URBAN DESIGN COMMISSION APPLICATION

SHEET LIST - ARCHITECTURAL	
SHEET NUMBER	SHEET NAME
PR0.0	COVERSHEET FOR PROPOSED CHANGES
PR1.1	BUILDING 1 & 2 PROPOSED CHANGES - FLOOR PLAN
PR1.2	BUILDING 1 & 2 PROPOSED CHANGES - ELEVATIONS
PR1.3	BUILDING 1 & 2 PROPOSED CHANGES - ELEVATIONS
PR1.4	BUILDING 1 & 2 PROPOSED CHANGES - ELEVATIONS
PR1.5	BUILDING 1 & 2 PROPOSED CHANGES - ELEVATIONS
PR1.6	BUILDING 1 & 2 PROPOSED CHANGES - ELEVATIONS
PR2.1	BUILDING 3 PROPOSED CHANGES - FLOOR PLAN
PR2.2	BUILDING 3 PROPOSED CHANGES - ELEVATIONS
PR2.3	BUILDING 3 PROPOSED CHANGES - ELEVATIONS
PR2.4	BUILDING 3 PROPOSED CHANGES - ELEVATIONS
PR3.1	BUILDING 4 PROPOSED CHANGES - FLOOR PLAN
PR3.2	BUILDING 4 PROPOSED CHANGES - ELEVATIONS
PR3.3	BUILDING 4 PROPOSED CHANGES - ELEVATIONS
PR3.4	BUILDING 4 PROPOSED CHANGES - ELEVATIONS
PR3.5	BUILDING 4 PROPOSED CHANGES - ELEVATIONS

MULTI-FAMILY HOUSING
THE MEADOWLANDS
MADISON, WI
KCG HOUSING DEVELOPMENT

THE MEADOWLANDS - PROPOSED SITE PLAN CHANGES

L2.2

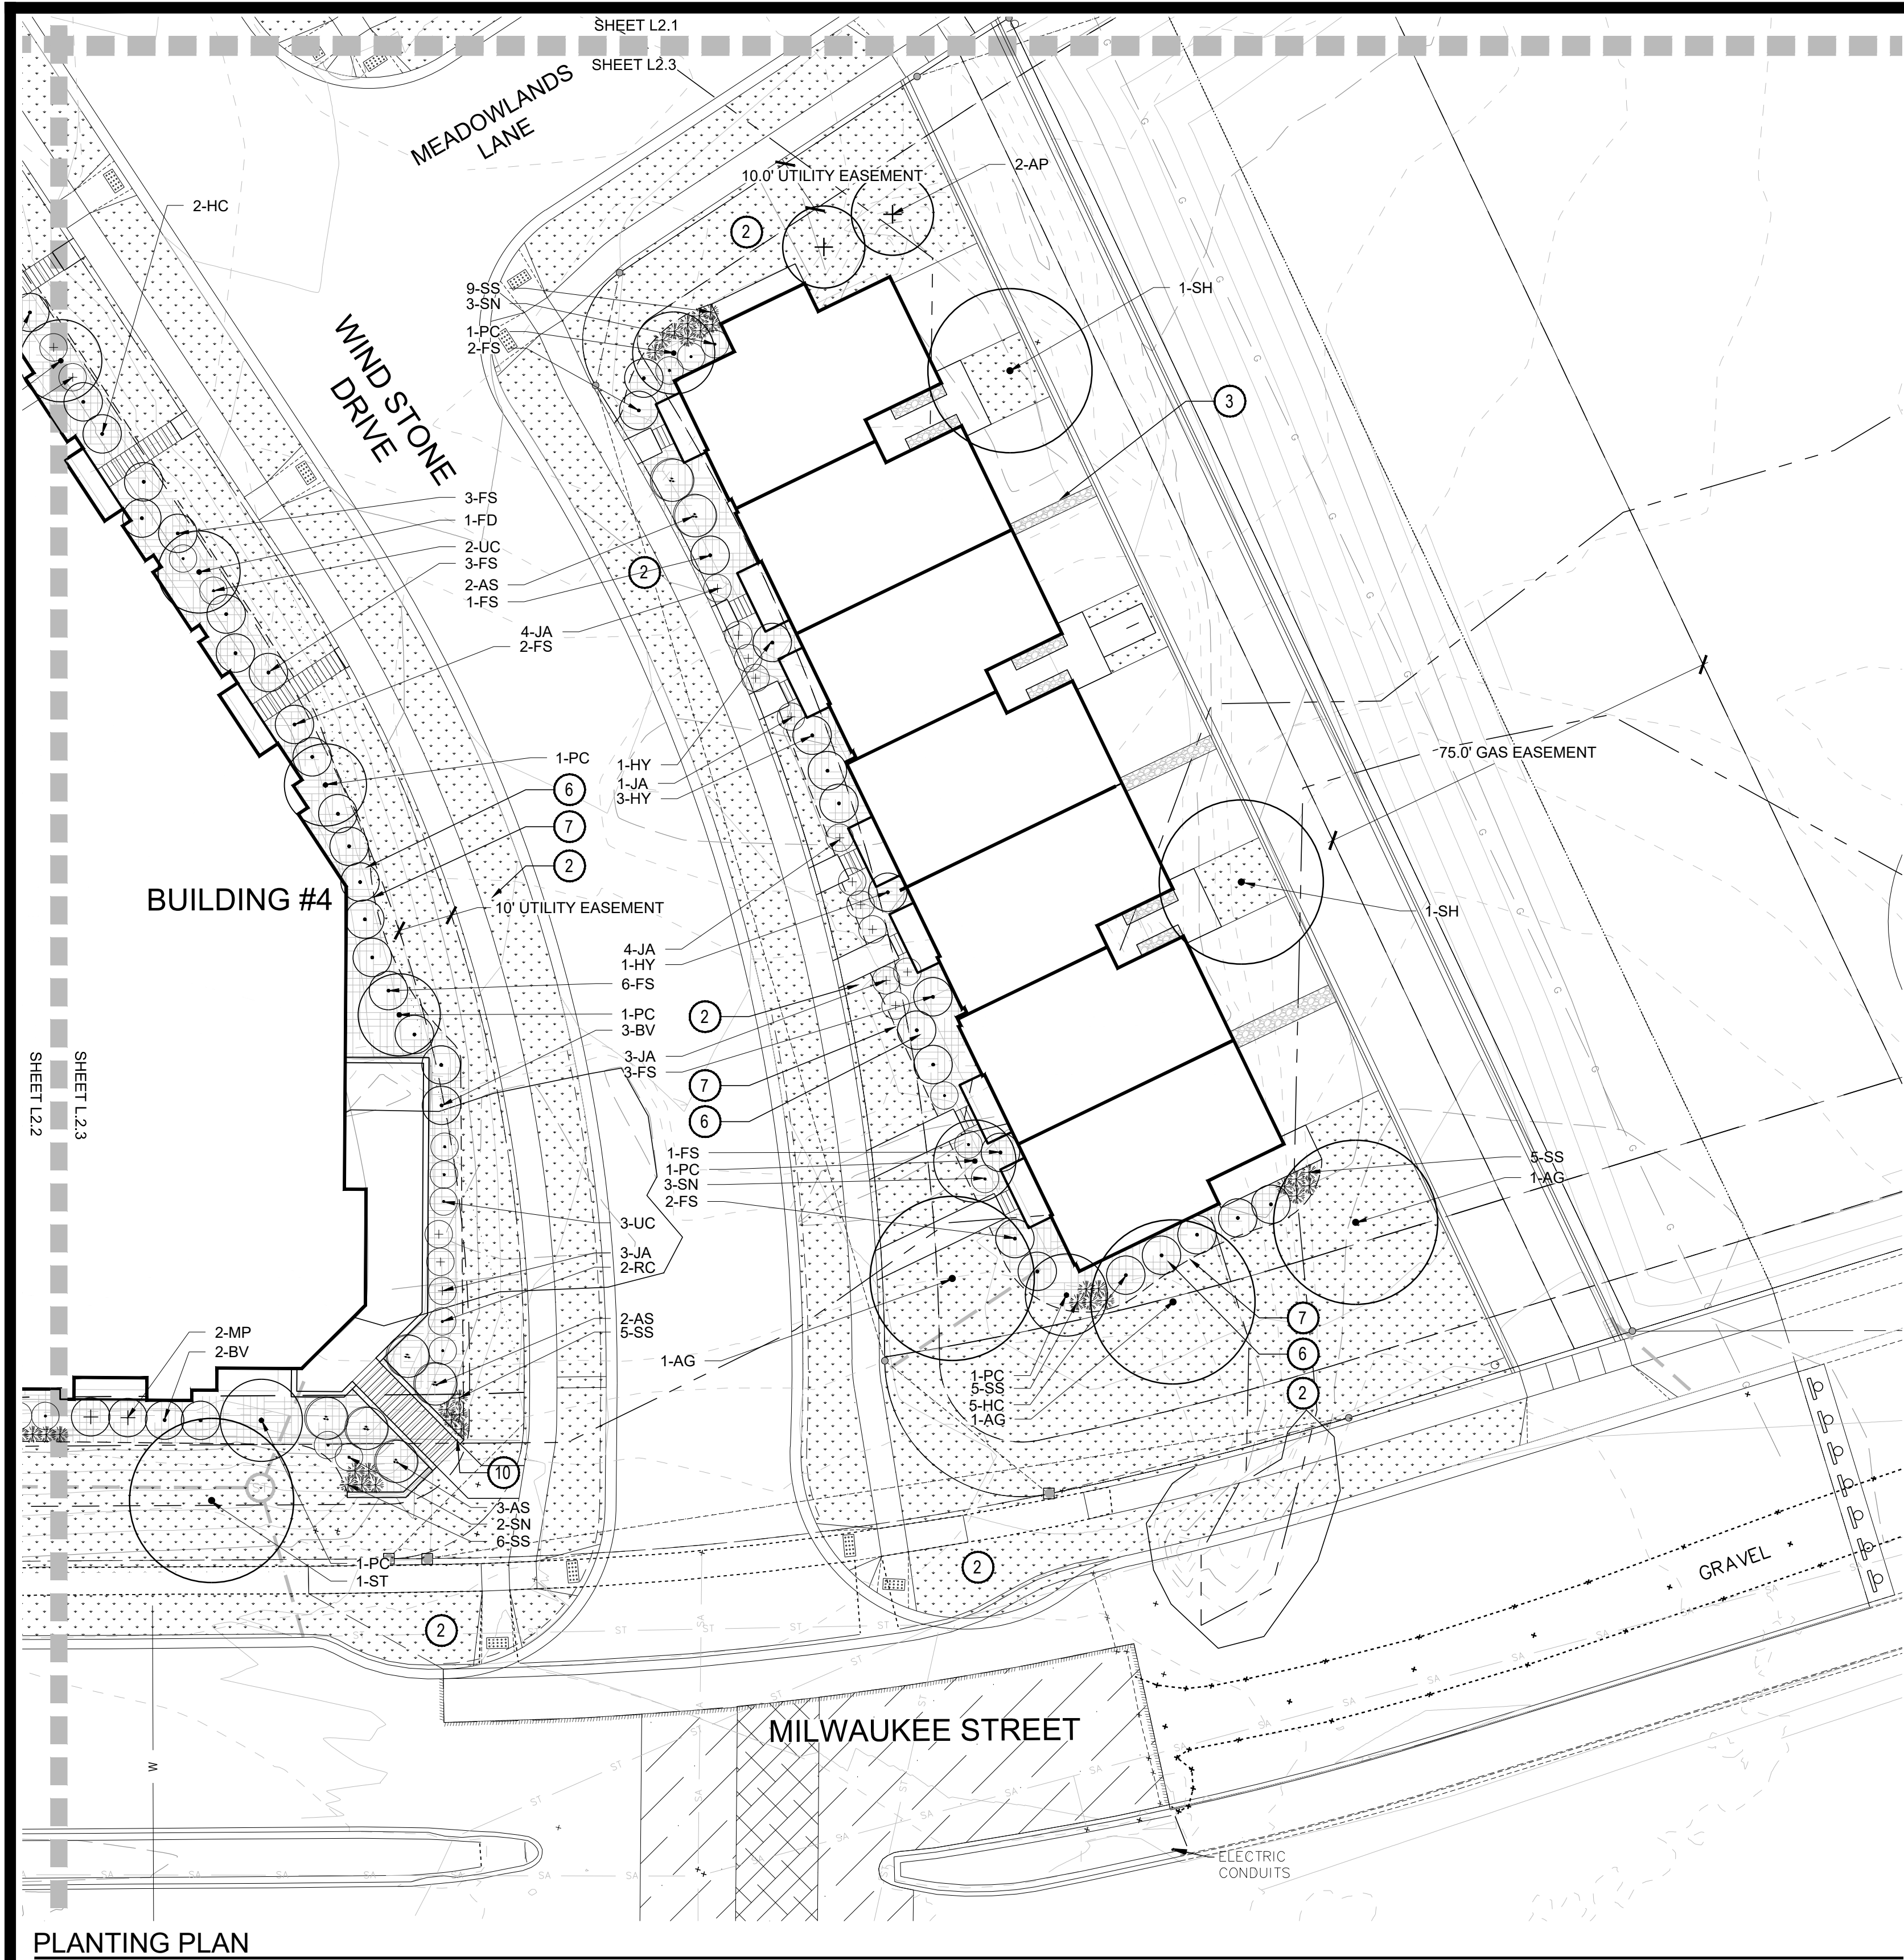
- All unit porches: provide ceiling mounted puck lights ILO sconce.
- Building 4 Hardscape Patio - reduce
 - Building 4 (interior courtyard side)
 - Reference Pages: L 2.2

- Proposed Revision
 - Revise patio layout, keeping similar overall usable SF
 - Eliminate decorative retaining wall as a result of layout revision
 - Simplify patio finish details, proposed to be standard concrete pour and broom finish
